ED-HMI3010-133C

PCN

1 Product Change Notice 1

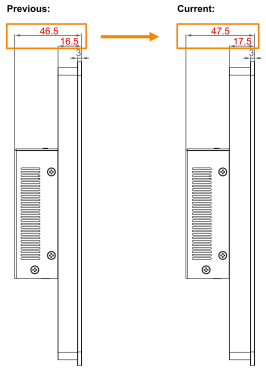
Changes	Results
LCD bezel thickness increased by 1mm	We have optimized the LCD bezel structure to provide additional clearance for internal cable routing. • LCD bezel thickness: adjusted from 16.5mm to 17.5mm. • Total product thickness: correspondingly adjusted from 46.5mm to 47.5mm.
